Lotus Elan M100 Service Bulletins  
Series 1 and Series 2 1990 - 1996

# SERVICE BULLETIN

1990/11

**TITLE:** Replacement of headlamp flap 'J' links.**REASON:** Incorrect material specification of some links may result in distortion of link and faulty operation of headlamp mechanism.**ACTION:** At the next opportunity (i.e. next time the vehicle is on the dealer premises), replace the headlamp flap 'J' links on all 1990 model year Elan and Elan S.E. models in the following VIN range:VIN serial number 6105 to 6192 inclusive.  
Check VIN of all dealer stock and demonstrators.**Parts Required**

View of steering rack  
with underframe  
removed

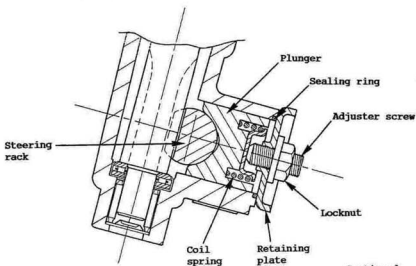
- TITLE:** Replacement of steering rack spring plunger.
- REASON:** Material specification improvement for extended durability.
- ACTION:** At the next opportunity, (i.e. next time the vehicle is on the dealer premises) replace the steering rack plunger on all 1990 model year Elan and Elan S.E. models, manual and PAS, in the following VIN range:

- Withdraw the underframe.
3. At the rear of the steering rack pinion housing, slacken the plunger adjuster screw locknut, and back off the adjuster screw to relieve some of the plunger spring pressure. Release the two screws securing the retaining plate (NOTE: Plate is spring loaded), and remove the plate, spring cup and spring.

4. In order to minimise oil loss, have the new plunger to hand before withdrawing the old plunger and inserting the new. If necessary, any oil loss may be corrected after re-assembly by injecting a similar quantity of EP 80 into the pinion end rack gaiter. (Total oil quantity in pinion/rack teeth area = 0.14 litre).

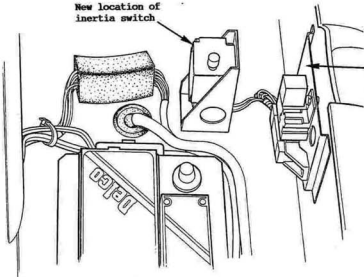
**TITLE:** Relocation of safety inertia switch.

1. Remove the battery compartment access cover.
2. Unplug the inertia switch, and release the two fixing screws.
3. Fix the switch to the new mounting bracket with the plunger nearest to the battery. Untape the switch harness lead sufficiently to allow the lead to be routed through the mounting bracket lightening hole before plugging onto the switch.

4. Thoroughly clean the area shown in the diagram where the new mounting bracket is to be bonded. Use the contents of Betaseal kit A075B6158J (used for windscreen fitment on all models) to wipe the bonding areas on both body and bracket with Betawipe.

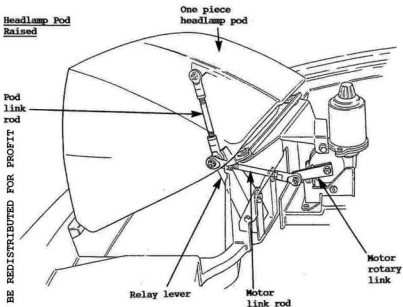
**TITLE:** Introduction of 'single pivot' headlamp mechanism. Revised fettling of right hand pod lower edge.

- Simplified headlamp mechanism and adjustment procedure.
- Revised fettling to provide increased clearance between pod and PAS hose.

1. Pod Shutlines; To adjust the pod shut height and shutlines, slacken the two bolts securing the hinge bracket to the topshell, and add/delete slotted shim washers as necessary to achieve correct pod height and alignment. Position the pod to achieve a 5mm (approx) shut gap between the pod and topshell/bonnet.

2. Motor Link; Adjust the length of the link between motor and relay lever to 140 mm between ball joint centres, with an equal amount of thread showing at each end of the link. Tighten the locknuts, ensuring that the two ball joints are parallel to each other. This dimension will ensure that the linkage goes just over centre with the pod raised, to provide a rigid prop.

#### Fettling of Right Hand Pod Lower Edge

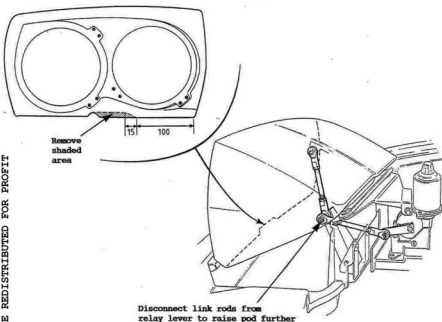
**ACTION:** At the next opportunity (i.e. next time the vehicle is on the dealer premises), all cars with the new headlamp system in the following VIN range, should have the fettling of the right hand pod checked/modified as detailed on pages 3/4.

On all cars listed in the introduction, raise the right hand pod, and check the profile of the pod lower edge against the template on the following page.

If necessary, the pod link rod should be disconnected from the relay lever to permit the pod to be raised further for improved access, and the lower edge marked out and fettled using a router or similar tool, until the profile matches that of the template. This will provide increased clearance of the pod edge (with pod lowered) to the low pressure power steering hose at the rear of the pod well. Inspect this hose for any signs of chafing, and replace if necessary.

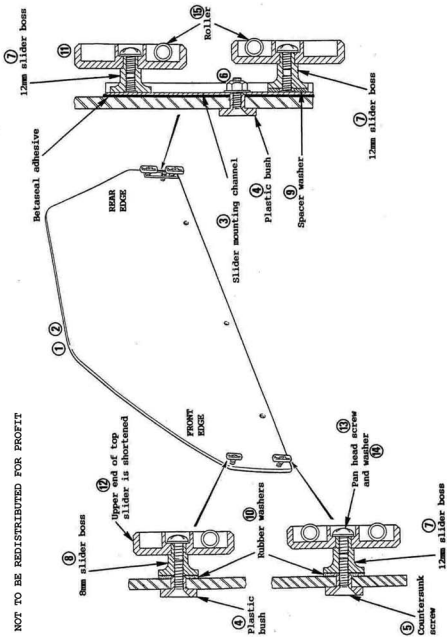
**REASON:** Clarification of assembly.

**ACTION:** Some early cars were fitted with only three door window glass slider blocks (2 front, 1 rear), before a slider mounting channel was introduced to enable two sliders to be fitted to the rear edge. This channel is bonded to the glass with Betaseal polyurethane adhesive, as used for the windscreen on all Lotus models. If ordering a service replacement door window glass for an Elan, it is recommended that a rear slider mounting channel be ordered at the same time. If replacing the glass on a car fitted with only three sliders, order additional parts (marked \*) to enable four sliders to be fitted.

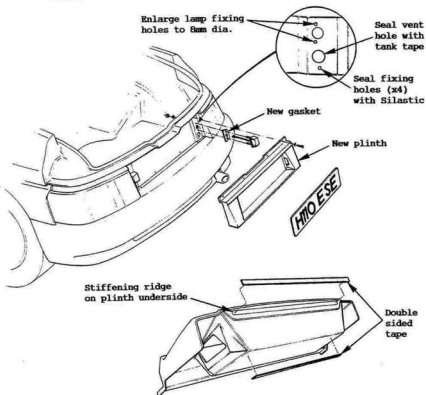
**TITLE:** Introduction of revised rear licence plate plinth.

The new type plinth is secured to the body using the existing 4 screws along the top edge, and double sided tape along the lower edges.

1. From inside the boot, remove the boot floor and rear lamp covers, pull up the bottom of the rear transom carpet and remove the 4 screws securing the lower edge of the licence plate plinth. Remove and retain the 4 screws and washers securing the top edge of the plinth, and remove the plinth. Clean any tape residue from the body.
2. Remove each of the two licence plate lamps by releasing the two nuts and the harness connector plug.
3. Open up the lamp fixing holes to 8mm diameter, fit a foam gasket on each lamp body, and refit the lamps but do not tighten the fixings.
4. Use tank tape or similar to seal off the ventilation holes in the body transom beneath the lamps, and seal the 4 fixing holes along the lower edge of the transom with Silastic.

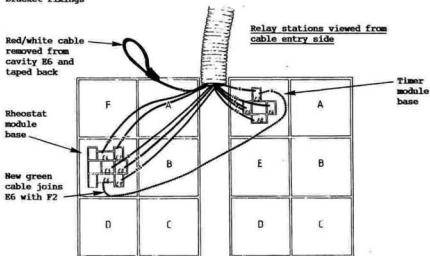
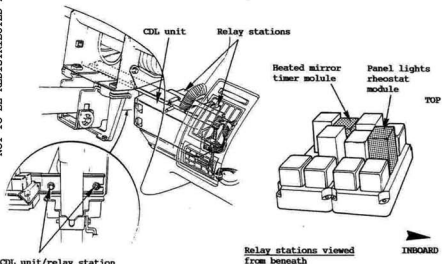
**TITLE:** Change to switching logic of panel lights.

**ACTION:** Vehicles from the following changepoint have been built with the harness change incorporated:

1. Remove the steering column shrouds. Slacken the nut and remove the setscrew securing the CDL unit/relay station mounting bracket to the steering column brace and lower the bracket assembly.

2. Remove the heated mirror timer module and rheostat module, and release the four screws securing each of the two 'six way' relay stations to the bracket.

3. Use a jewellers screwdriver or similar to remove the red/white cable from cavity E6 of the rheostat module base. Insulate and tape back.
4. Remove the green cable from cavity F2 of the heated mirror timer module base and cut off the terminal. Add 250mm of 0.5mm<sup>2</sup> green cable, and terminate the pair of cables with the longer legged spade terminal supplied in the kit. Refit the terminal into cavity F2 of the timer module base.

6. Refit the relay stations to the mounting bracket, and insert the relays. Refit the bracket assembly to the steering column brace.
7. In the passenger footwell, replace the existing 3A fuse in slot 19 of fusebox A (heated mirror timer), with the new 7.5A fuse.

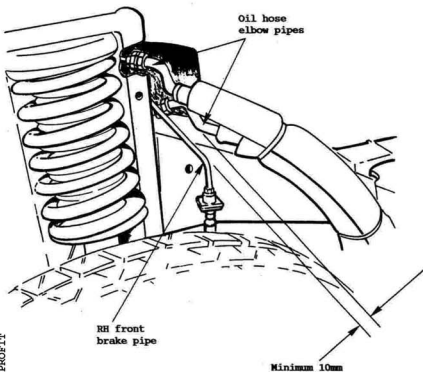
**REASON:** To ensure adequate clearance is maintained after disturbance of an oil hose connector union. Feed and return connections for the oil cooler are provided at the right hand rear of the engine, adjacent to the RH front suspension turret. The two oil cooler hoses which connect to these unions use short elbow pipes at the engine end to permit their routing between the topshell and longeron. Care must be taken when tightening these joints to achieve the correct elbow pipe orientation and provide sufficient clearance between the elbow pipes and the adjacent brake pipe, allowing for the full range of engine movement on its rubber mountings.

1. Remove the RHF wheelarch liner.
2. Carefully examine the elbow unions and brake pipe for signs of chafing or damage, using a mirror if necessary, and renew components if necessary.
3. Check for oil hose elbow pipe clearance as shown in the illustration. There should be a minimum gap of 10mm between both the elbows and:
  - the brake pipe;
  - the chassis longeron;
  - the body topshell.If necessary, slacken the elbow pipe union nut and reposition the elbow, and/or bend the brake pipe to achieve the specified condition. Torque tighten the union nuts to 27 Nm (20 lbf.ft).
4. Refit the wheelarch liner.

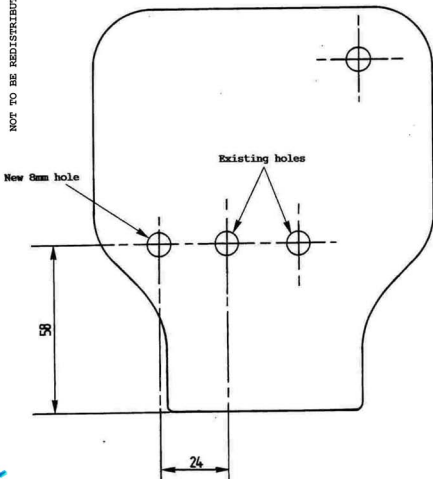
**REASON:** Due to recent clarification of international legislation on permitted microwave frequencies and power outputs, the Gemini '1059' microwave sensor supplied with Lotus Elan Vehicle Alarm System kits, is to be replaced by a revised version which uses a different frequency and also incorporates improved sensitivity adjustment control.

1. Remove the mat from the parking brake lever recess, and by referring to the attached template, check whether the modification has already been carried out, as indicated by the presence of the additional (offset) hole for the microwave sensor LED. If the sensor is found to be fitted in the new offset position, take no further action.

8. Adjust the sensitivity (range) of the new sensor during the 40 second delay period after arming as follows:  
Remove the tunnel tray mat, observe the pilot light, and arm the system. After a 10 second stabilisation period, wave an arm at a progressively decreasing distance from the microwave sensor, until the pilot light flashes and indicates that the movement has been detected (alarm triggered). Turn the alarm off and on again to restart the arming delay period, and check the point of detection when approaching from several different directions. Test with the roof both raised and stowed, and adjust if necessary by turning the sensor screw clockwise to increase sensitivity (range) or counterclockwise to decrease sensitivity.

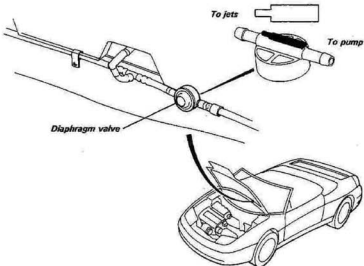
Relocation of windscreen washer diaphragm valve.

To prevent 'dribbling' from washer jets.

A spring loaded diaphragm valve is fitted in the windscreen washer tubing in order to close off the pipeline unless pressurised by the pump. This device is designed to prevent self-siphoning and dribbling from the washer jets. On early cars, the valve is located next to the washer bottle in the boot, but the inertia of the water column between the valve and jets can, under hard braking or cornering, result in sprinkling from the jets.
